# *Florence County Government*

### **ADDENDUM NO. 2 - FRIENDFIELD FIRE STATION (BID NO. 2-16/17)**

CONSTRUCTION PLANS  
FOR:  
**HANNAH-SALEM-FRIENDFIELD  
FIRE DEPARTMENT  
NEW STATION AT FRIENDFIELD**

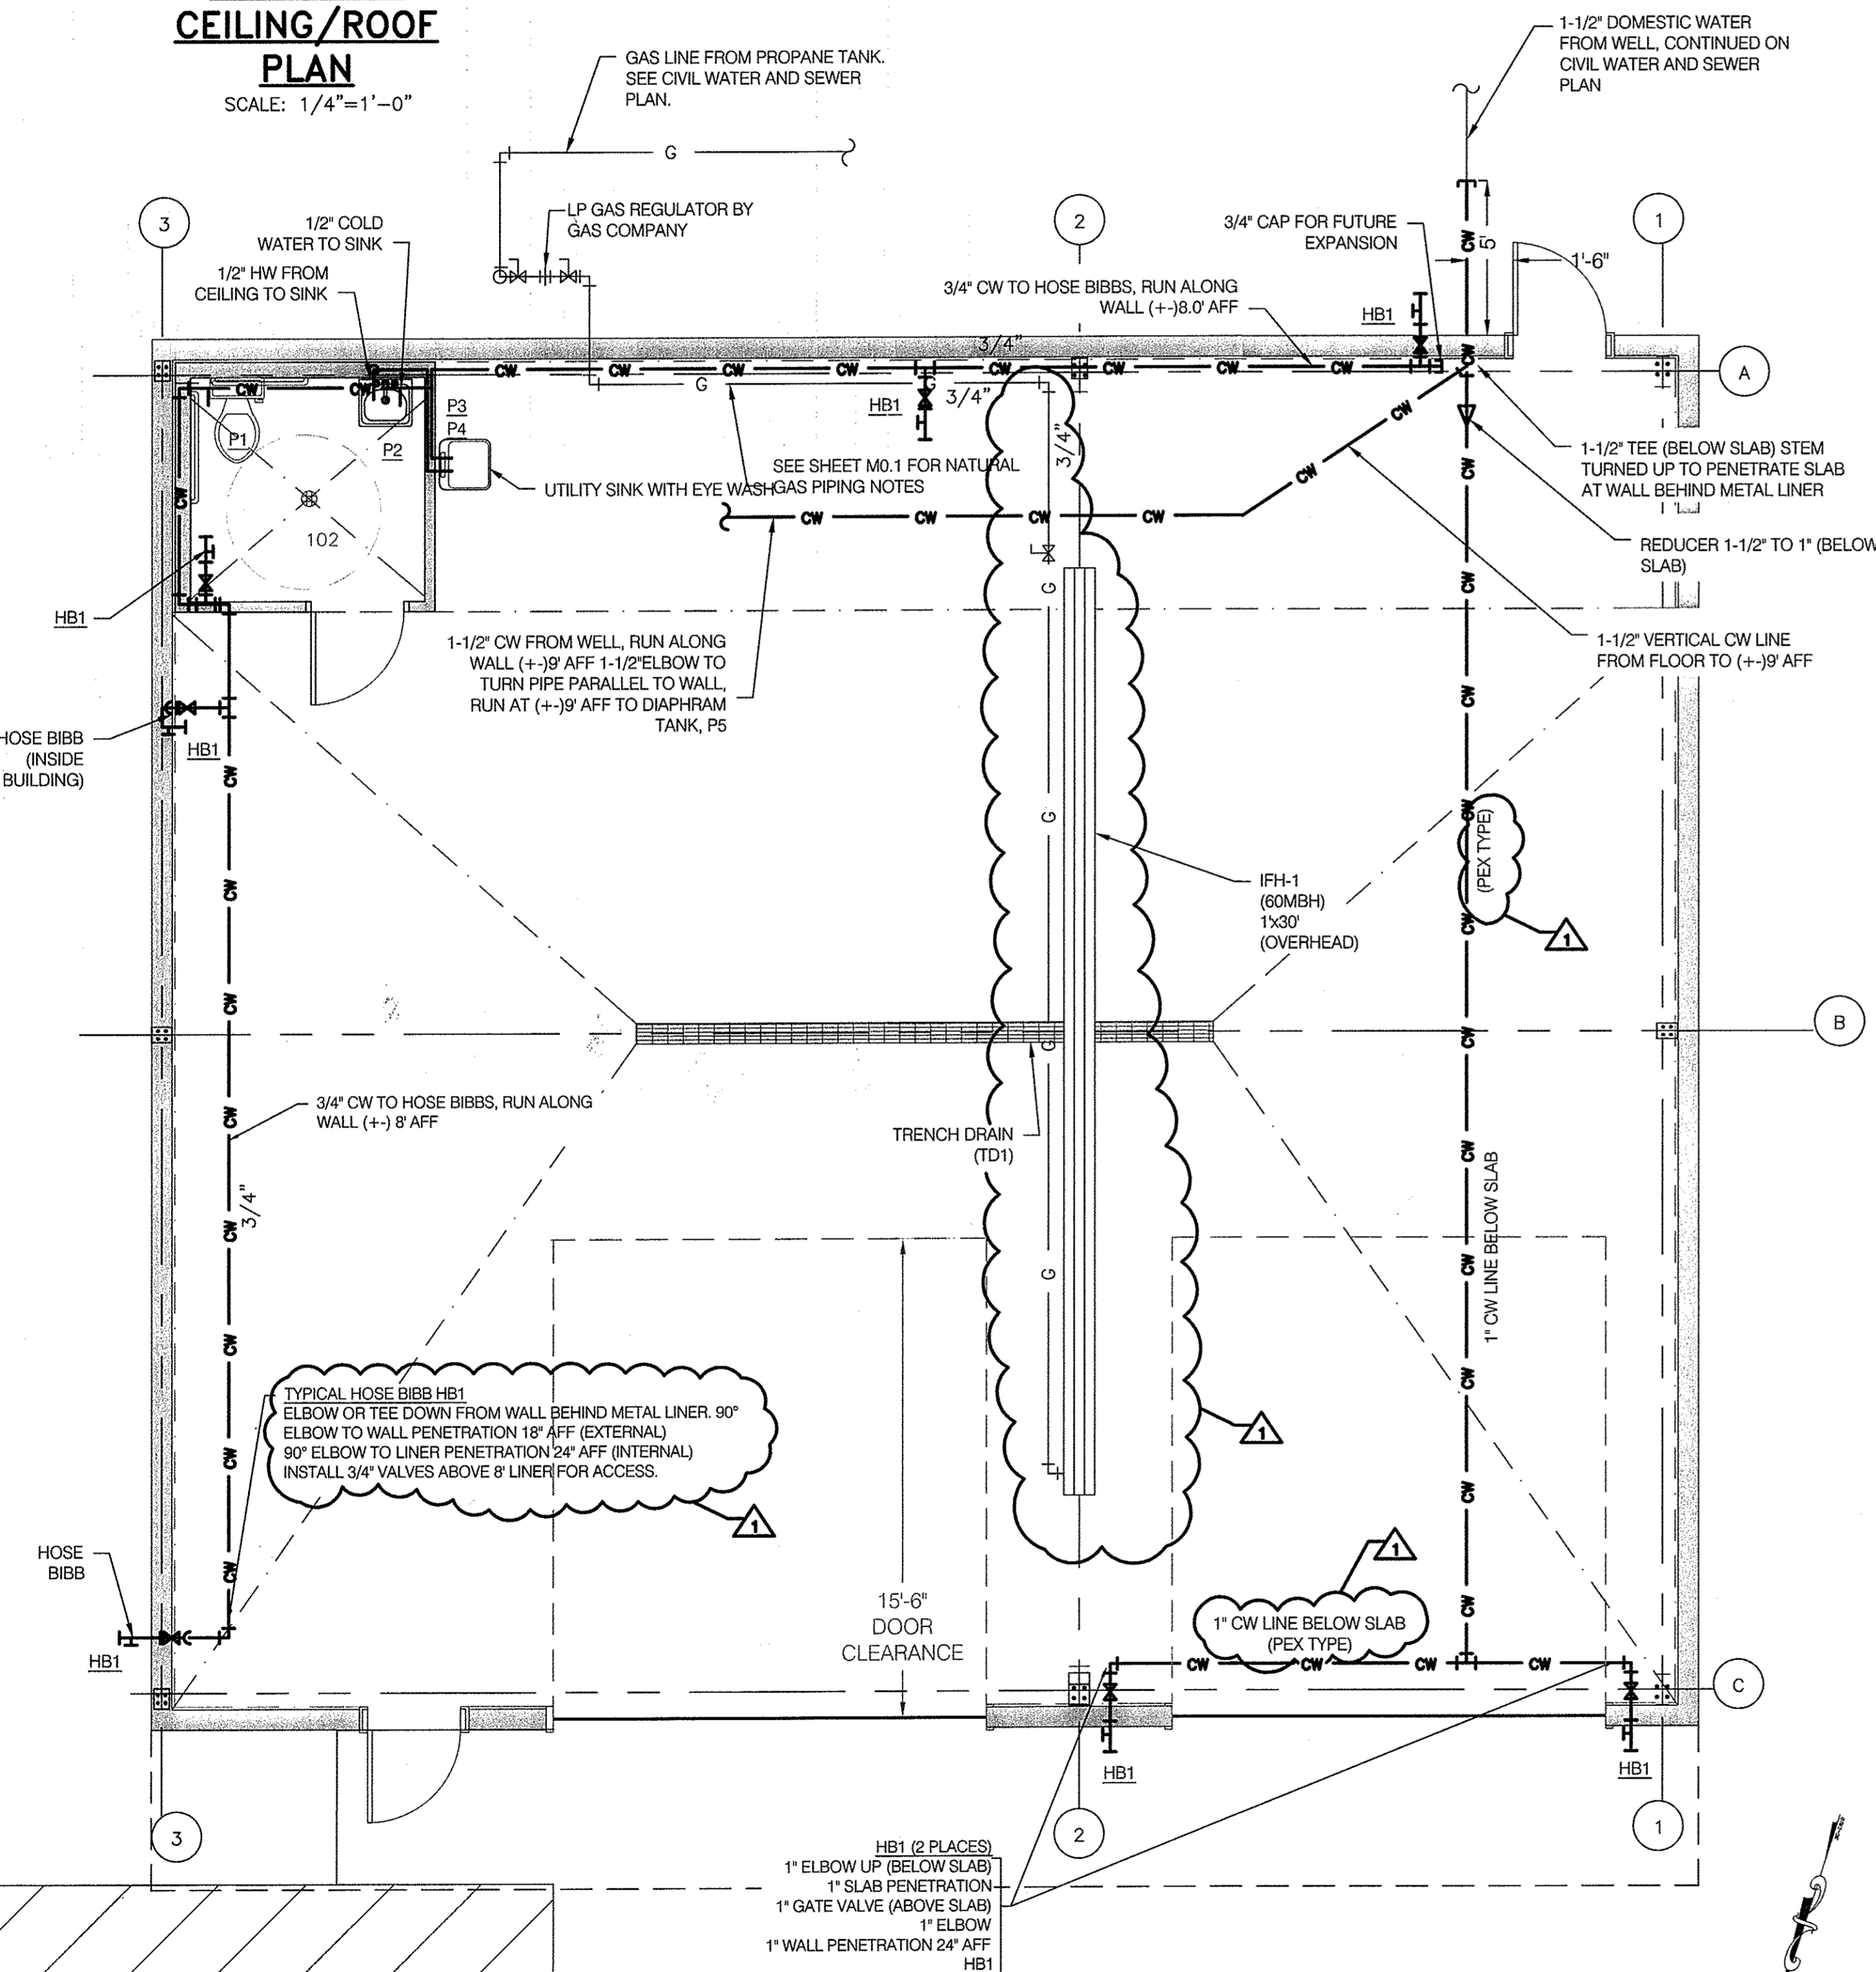
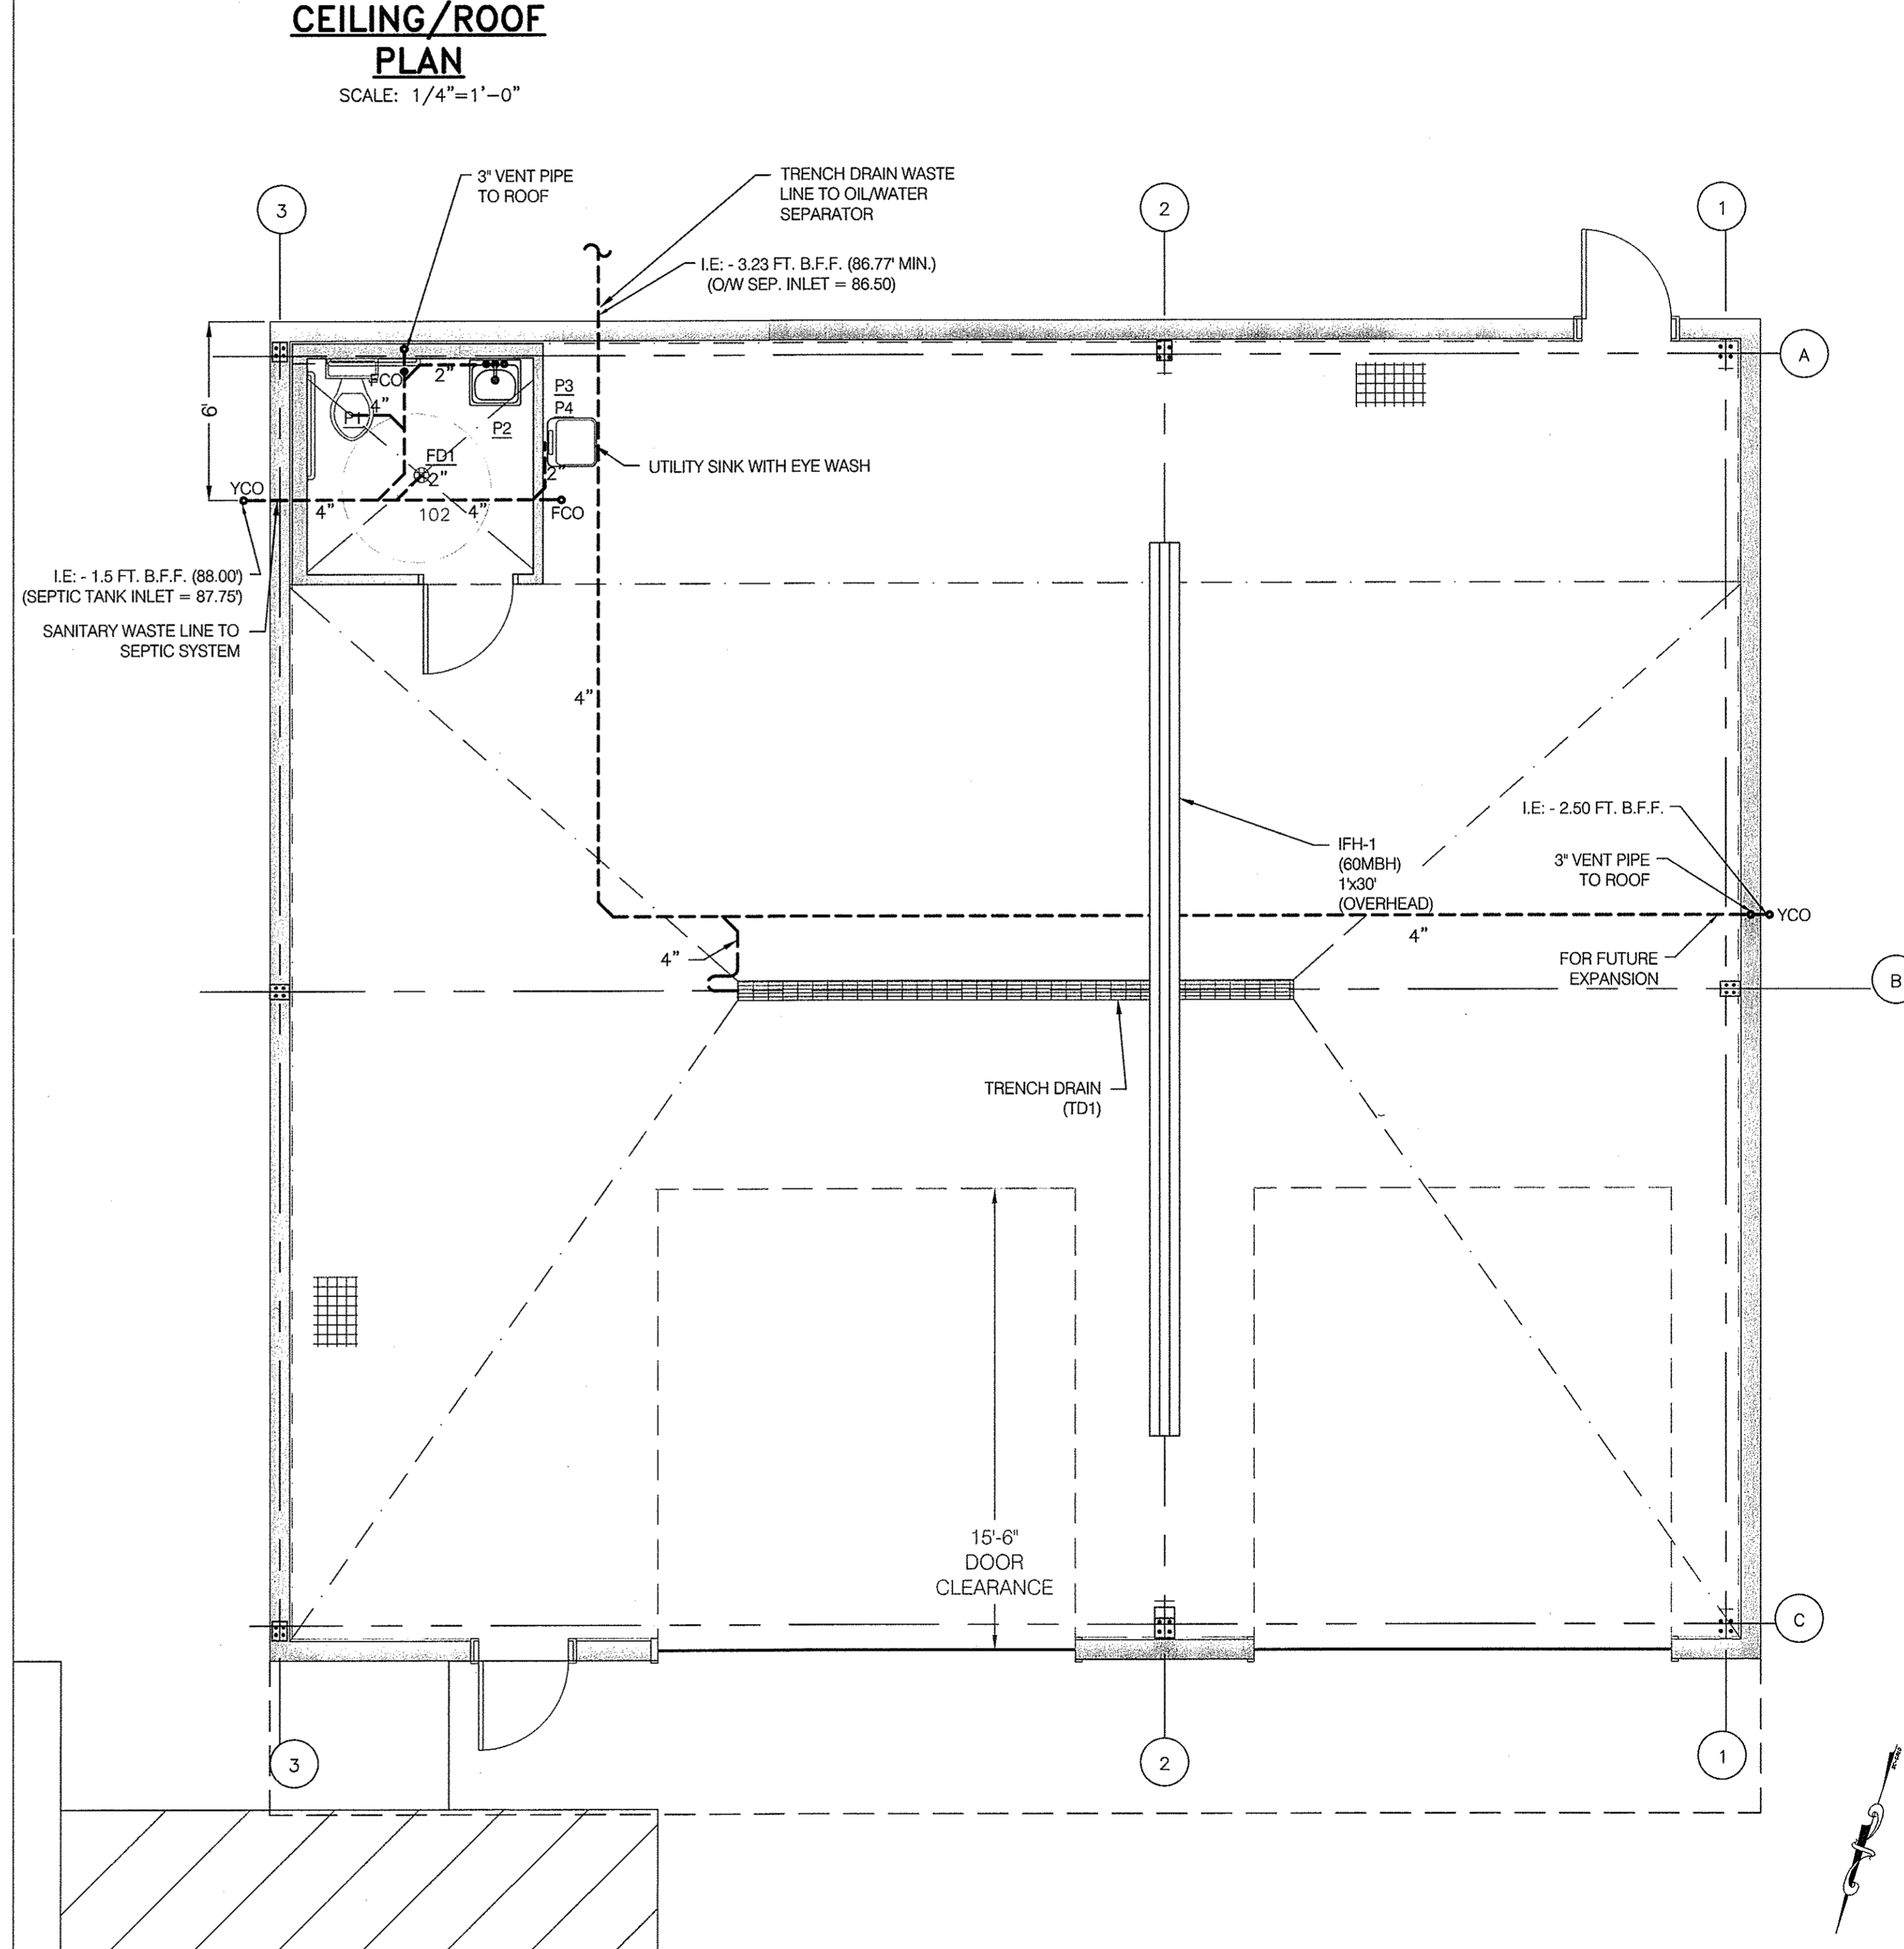
- Sheet P1.0 Exterior hose bibb HB1 shall be keyless & frostless.
- Sheet P2.0 Pex type cold water pipe is allowed below the slab.  
On hose bibs protruding from behind the metal wall liners, the shut-off valve is set above the liner for easier access.
